COOL UPDATE

Your go-to newsletter for technical updates and latest changes in refrigeration and industrial solutions—delivered nearly every month.

Introduction

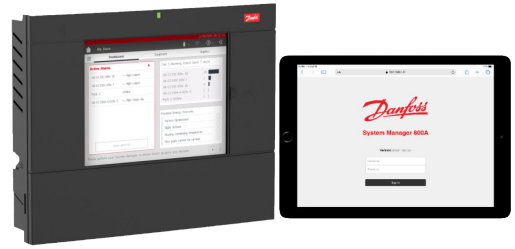
Due to introduction of new ICAD B actuator and phase-out of ICAD A version, it was decided to implement new O-ring for ICAD B version in all ICM, ICMTS valves, CVE pilot valves and ICM modules in ICF valve stations.

New ICAD B O-ring is fitted in new location, in a place where ICAD A wear ring was seated before. New ICAD B O-ring has different size and diameter and cannot be used for ICAD A actuator.

Fully assembled valves will be delivered only with new ICAD B O-ring. The O-ring will be attached to the magnetic coupling with plastic bag and short instructions (please see the photo below). This is done due to risk of the O-ring falling off by transportation.

If the valve needs to be coupled with ICAD A, the wear ring and ICAD A O-ring must be ordered separately:

- Spare part 027H0356 for ICM 20-32
- Spare part 027H0357 for ICM 40-150, ICMTS and CVE

Top modules for ICM 20-65 and ICMTS modules, which are often used as spare parts, will be delivered both with ICAD B O-ring and ICAD A wear ring and O-ring.

- The ICAD B O-ring will be attached to the magnetic coupling with a plastic bag and short instructions.
- The ICAD A wear ring and O-ring will be inside a plastic bag with short instructions included into the box, but not attached to the valve (see photo on the left)

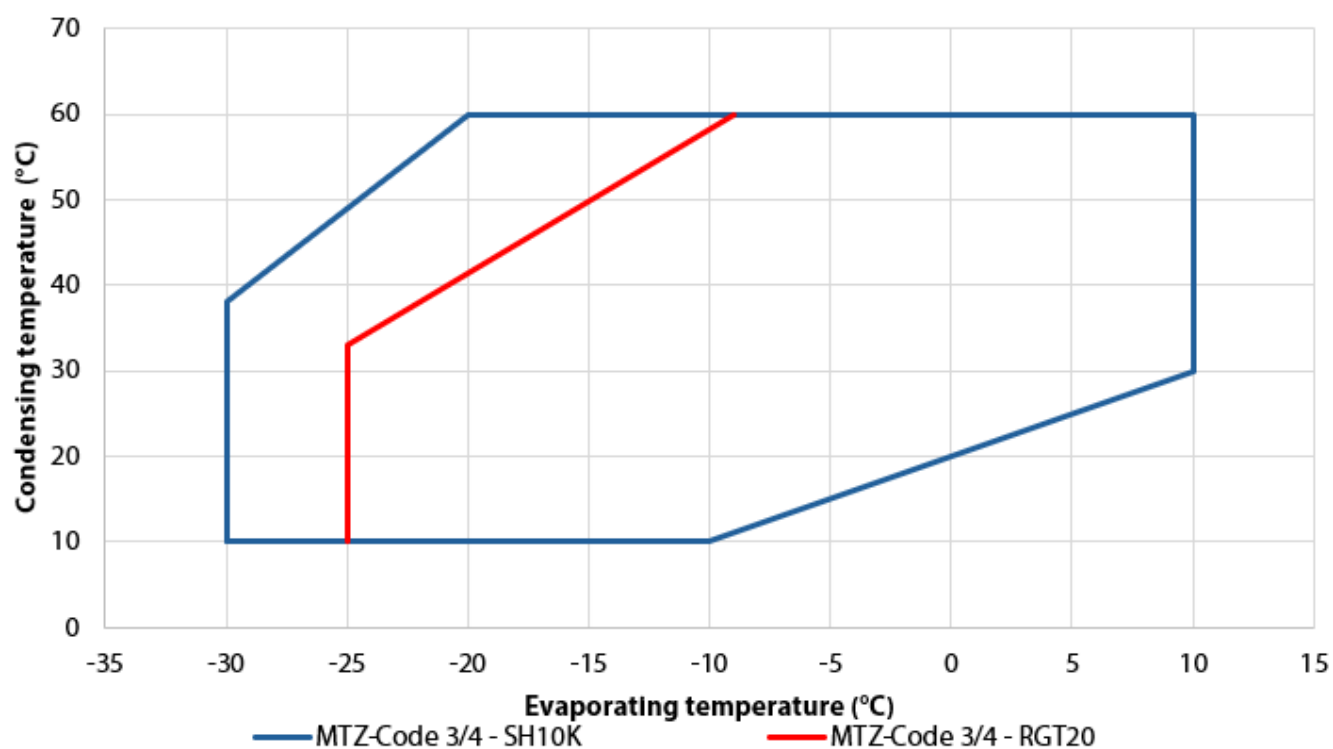
R454A/C and R455A are zeotropic refrigerants with a temperature glide of about 6 to 12K and must be charged in the liquid phase. To prevent oil dilution, a crankcase heater is recommended. It protects against refrigerant migration and maintains the oil temperature 8–10K above the saturated LP temperature. Tests should be conducted to ensure an appropriate oil temperature under all conditions. A PTC crankcase heater is recommended for all stand-alone compressors and split systems. Under extreme conditions, a belt-type crankcase heater may be used in addition to the PTC heater.

Please follow the operating map presented below

PSH039A4 50Hz VI envelope extension

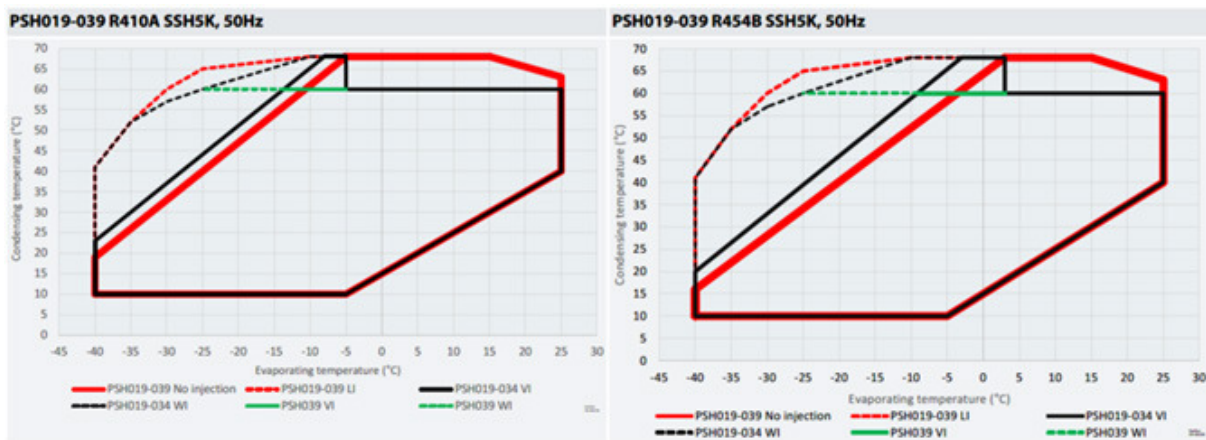
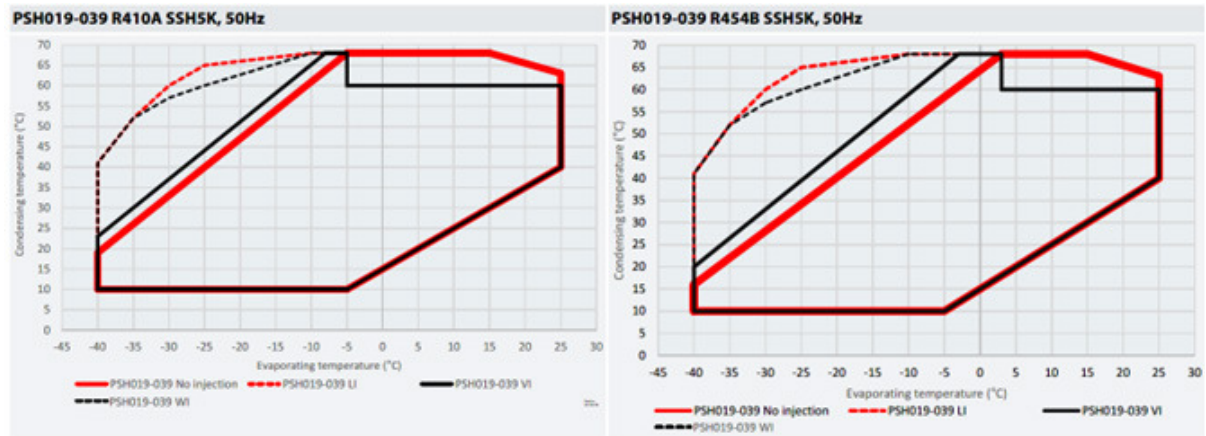
Starting from last October, the 50Hz VI envelope of the PSH039A4ELA/FLA had been released with a maximum condensing temperature of 60 °C, compared to other PSH models at 68 °C . We are pleased to announce that after developing a new overload protector, the envelope can now match the area of other models, effective from August 2025.

The 50Hz VI envelope of PSH039A4ELA/FLA is extended, with no changes to the 60Hz envelope.

Current envelope of PSH039 50Hz

Updated envelope of PSH039 50Hz

Envelop with A2L refrigerants

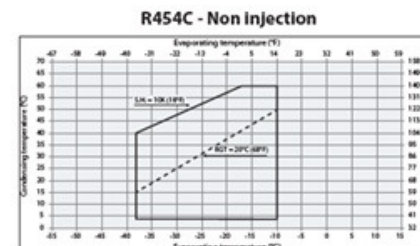
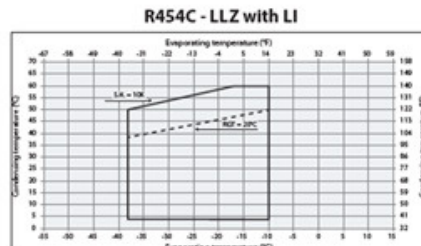
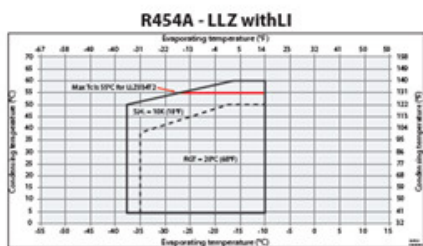
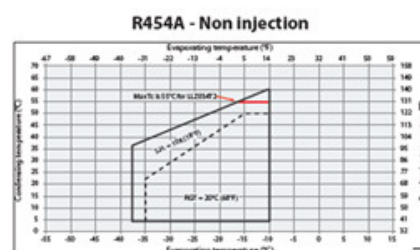
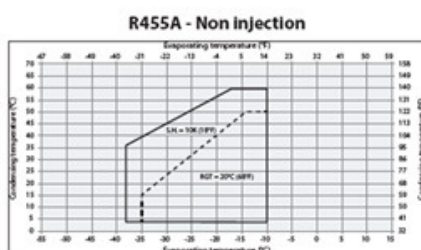
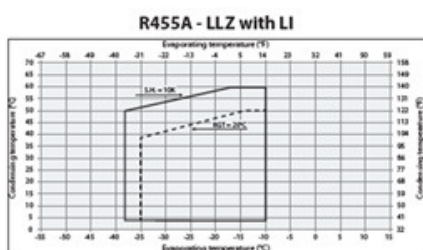
Now, new models MLZ/LLZ (motor code 1 & code 2) version C (UL only) with refrigerant R454A, R455A, R455C have been released in June 2025.

Operating map (R454C with SH=10K):

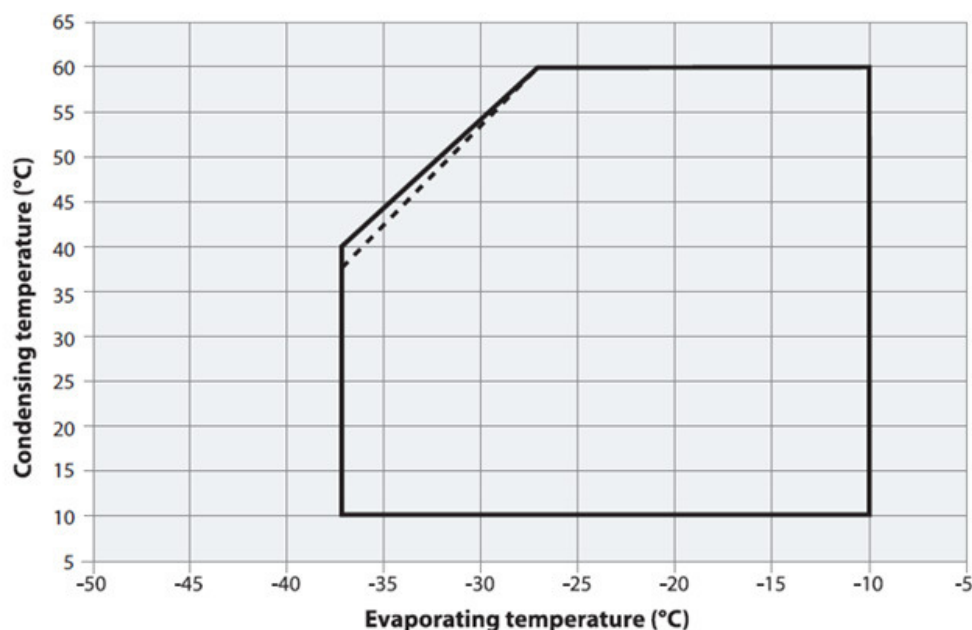
All NTZ096-4 compressors, starting with serial number 1009503203, effective July 9th 2025, are qualified with R454C respecting operating map presented on the next page.

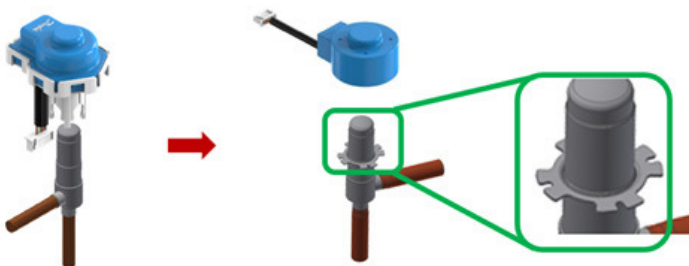
The new ETS 5M coil features following specifications:

The valve is adjusted with an additional fixing ring outside of the rotor tube to clip the coil. Inner valve design and performance are unchanged.

Please note that the existing valve/coil are NOT compatible with the new design.
